TO: Mercedes-Benz Dealers, General Managers, Sales Managers, Service Managers, Parts Managers	FROM: Anthony Washington, Senior Manager, Regulations and Certifications
Re: Service Campaign Notification Model: Sprinter (907) Model Years: 2023 Replace Rear Transmission Mount	DATE: June, 2024

IMPORTANT SERVICE CAMPAIGN INFORMATION

Campaign No. :	Campaign Desc. :	Replace Rear Transmission Mount
2024060006	VS3VERGET	
This is to notify you of a Service Campaign to Replace the Rear Transmission Mount on approximately 76 MY 2023 Sprinter Vans. All affected VINs will be flagged as "OPEN" in VMI.		
Background		
Issue	MBAG has determined that the rear transmission mount was not installed per production specifications.	
What We’re Doing	As a precautionary measure, MBUSA will replace the rear transmission mount and necessary hardware on the affected vehicles.	
Parts	Parts are available.	
Vehicles Affected		
Vehicle Model Year(s)	2023	
Vehicle Model	Sprinter	
Vehicle Populations		
Total Vehicles	76	
Dealer Inventory	0	
Next Steps/Notes		
AOMS/SOMS	Please ensure your dealers have read and understand this notice	
While we regret any inconvenience this may cause, MBUSA are determined to maintain a

D22.10-A018-75

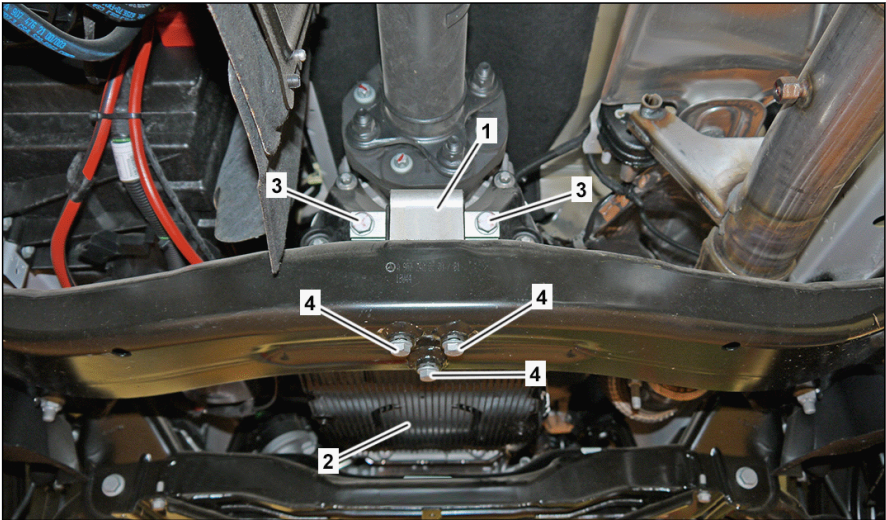
Danger	Risk of death caused by vehicle slipping or toppling off of the lifting platform.	Align vehicle between vehicle lift columns and position the four support plates at the vehicle lift support points specified by the vehicle manufacturer.	AS00.00-Z-0010-01A
	Replace		
1  Notice	Raise vehicle. Special instructions for lifting and supporting vehicle		AH00.60-P-0100-01TS
 AR			AR00.60-D-1000-04TS
 WS	000 588 26 80 00 Adapter		WS00.00-Z-0067KOB
 WS	000 588 41 80 00 Adapter		WS00.00-P-0321B
 WS	000 588 27 80 00 Adapter		WS00.00-P-0068B
2  AR	Remove underfloor panels.	If installed.	AR61.30-D-1001TS
3  WS  WS	Support transmission (2) at center. 000 588 24 62 00 Major assembly mount 000 588 23 62 00 Mounting plate		WS01.00-P-0253B WS26.00-P-0415B
4	Remove screw/bolts (3).	 Installation: Replace screw/bolts (3).  Screw/bolt, rear engine mount to transmission	BA22.10-Z-1001-01TSR

5	Unscrew screws (4). Notice Notes on threaded connections fastened using a tightening angle-based tightening process	i Installation: Replace screws (4). First attach bolts (4), then tighten together with bolts (3). Nm Bolt, rear engine mount to rear engine support	AH00.00-P-0020-01A BA22.10-Z-1003-01TSR
6	Remove and replace transmission mount (1).		
7	Install in the reverse order.
